TRENCH LAYOUT FOR 400KV SWITCHYARD (PLAN)

PROJECT	2X660 MW UDANGUDI SUPERCRITICAL TPS, STAGE-I
CUSTOMER	 TAMILNADU GENERATION AND DISTRIBUTION CORPORATION LIMITED (TANGEDCO)
CONSULTANT	 TATA CONSULTING ENGINEERS LIMITED BENGALURU
	BHARAT HEAVY ELECTRICALS LTD TRANSMISSION BUSINESS GROUP ...NOIDA

2 X 125 MVAR, 420KV, 3-PHASE, ONAN, SHUNT REACTOR.

OUTLINE GENERAL ARRANGEMENT

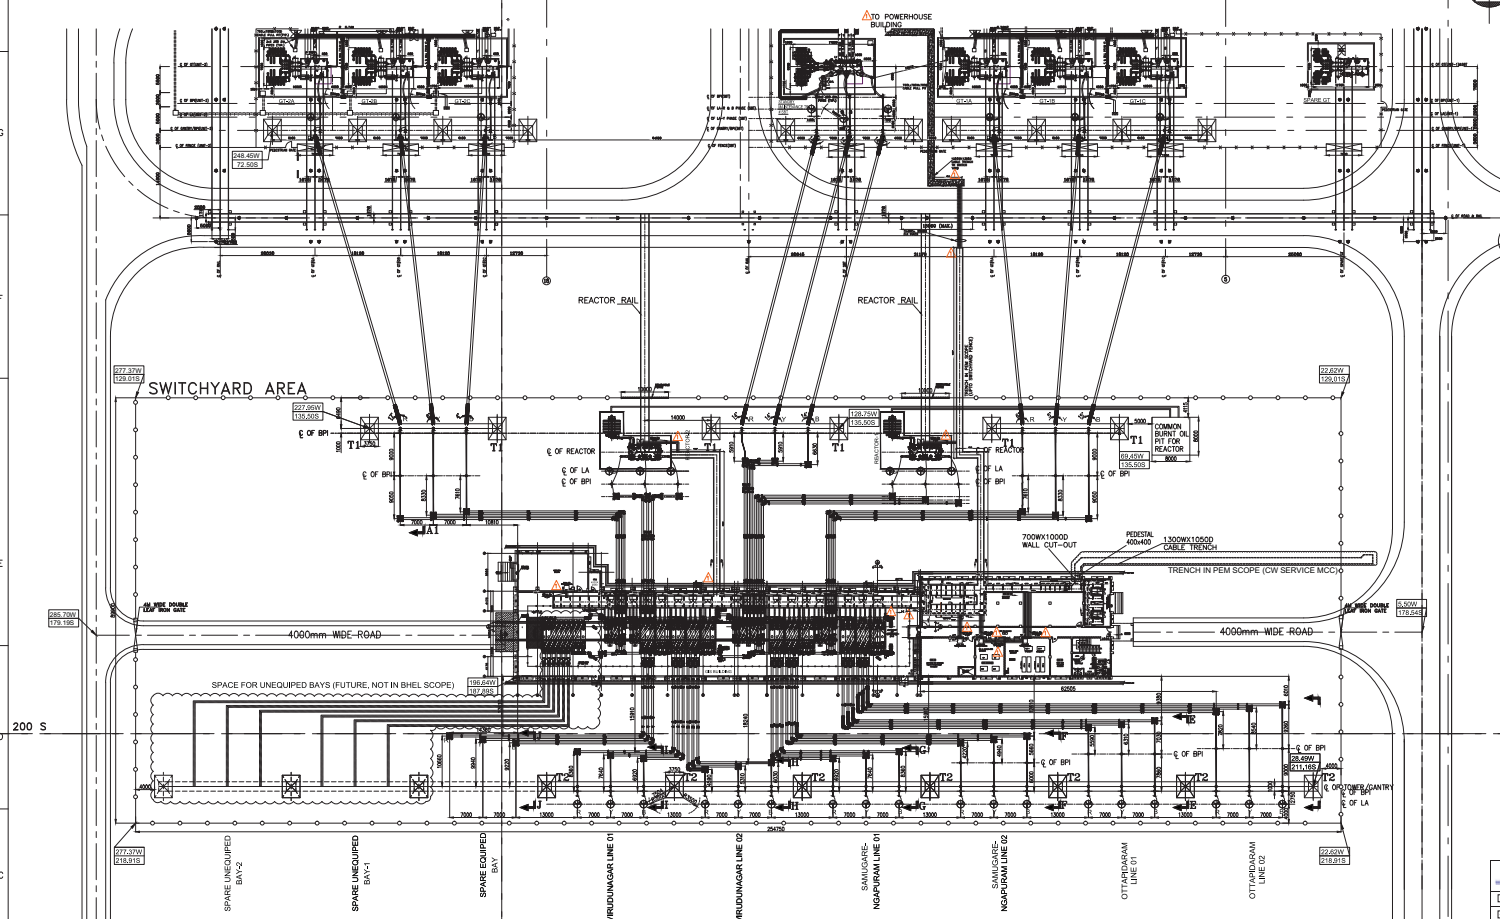
REVISED AS PER THE COMMENTS
VED: 114A33A-EL-V01-62
DATED: 12.03.2020

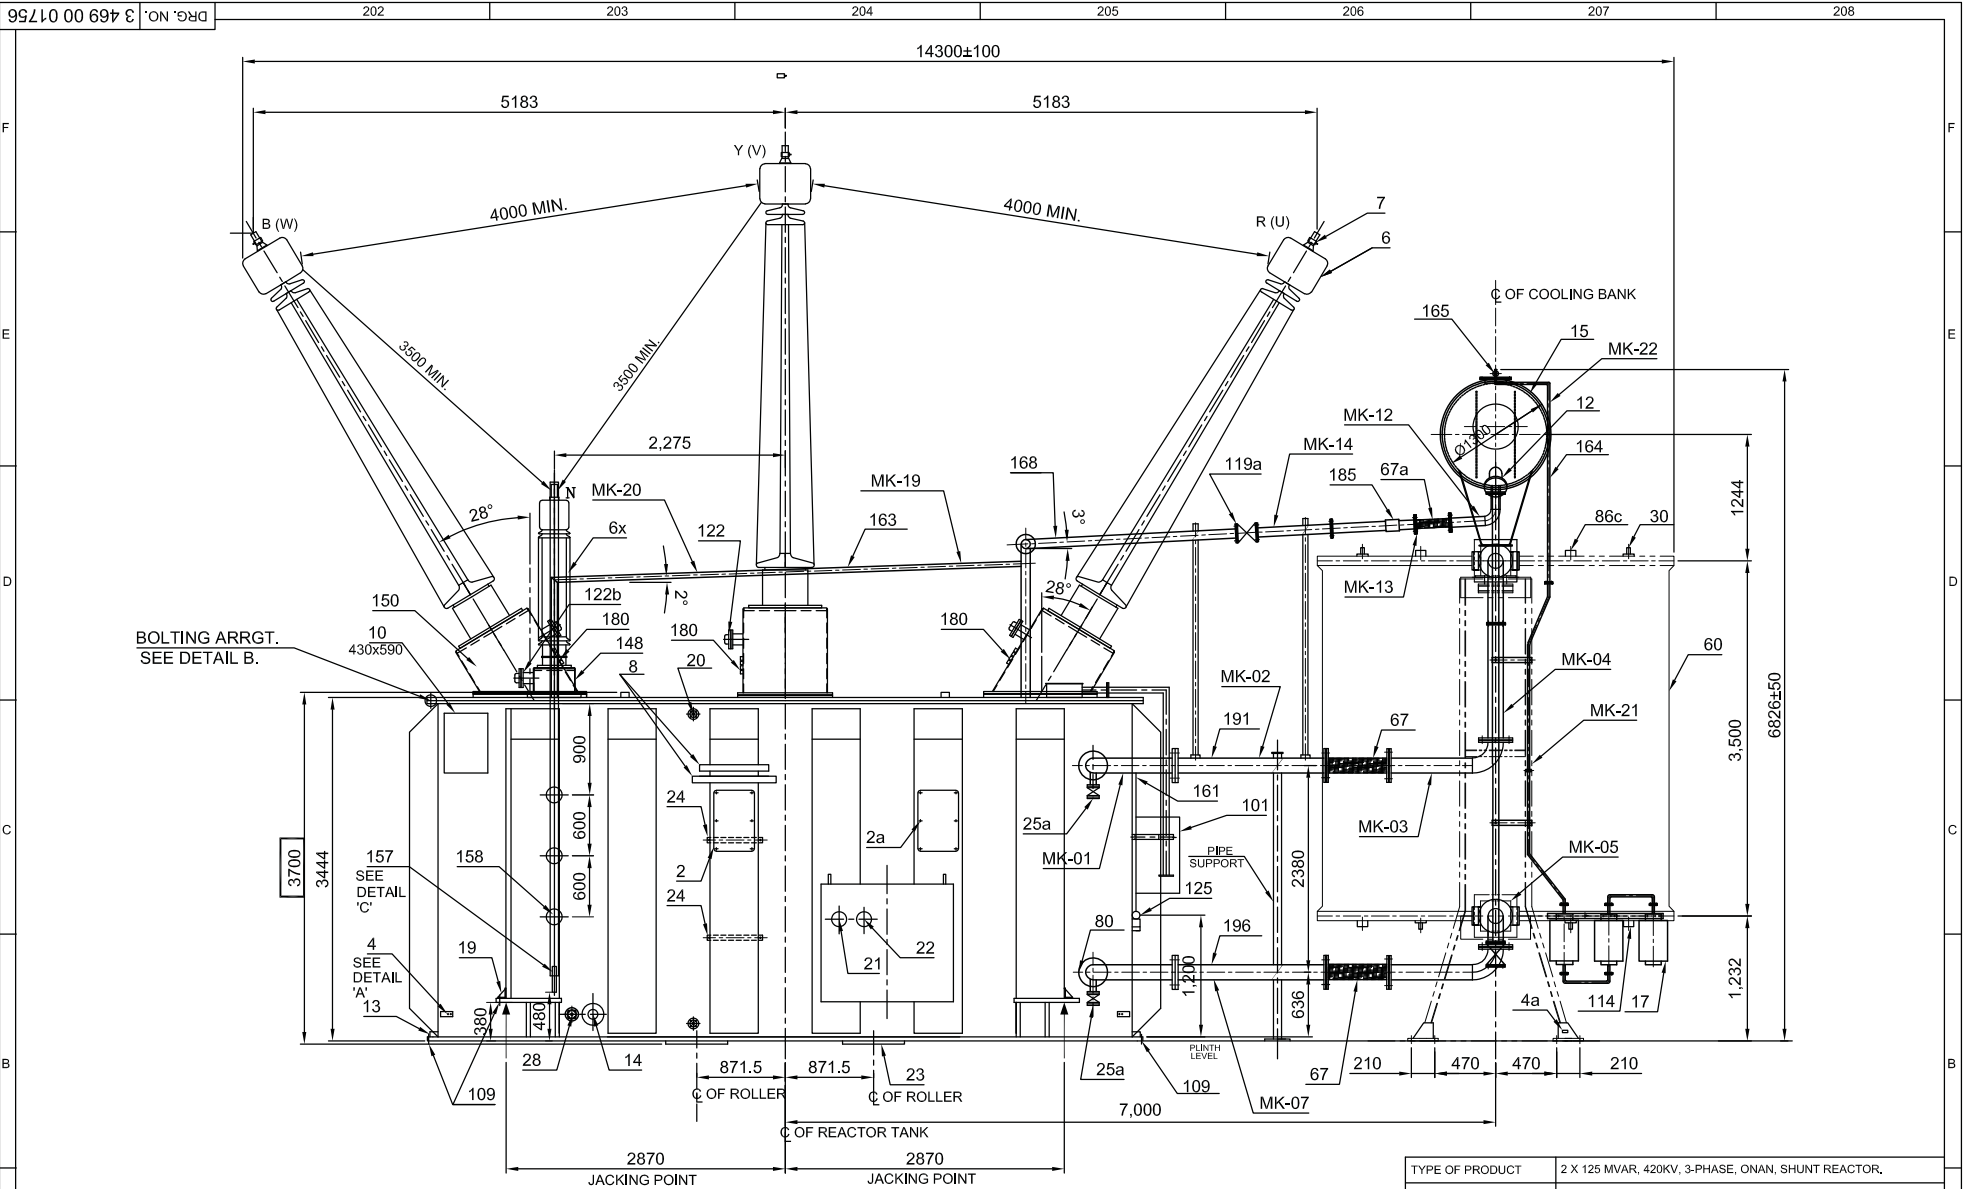
REV	DATE	ALT.		REV	DATE	ALT.		REV	DATE	ALT.	MKP		REV	DATE	ALT.	MKP	-SD-	
		CKD.				CKD.		02	04.10.19	CKD.	KD/AJ		01	30.07.19	CKD.	KD/AJ	-SD-	
		APPD.				APPD.				APPD.	KD/AJ				APPD.	KD/AJ	-SD-	
ZONE				ZONE				ZONE	COMMENTS INCORPORATED AS PER LETTER NO. 11403A-EL-VDT- 186 DTD.07/08/19					ZONE	DESIGN BASIS AND SIZING (RATING) OF SHUNT REACTOR ALREADY SPECIFIED IN TECHNICAL SPECIFICATION. ENCLOSED HERewith.
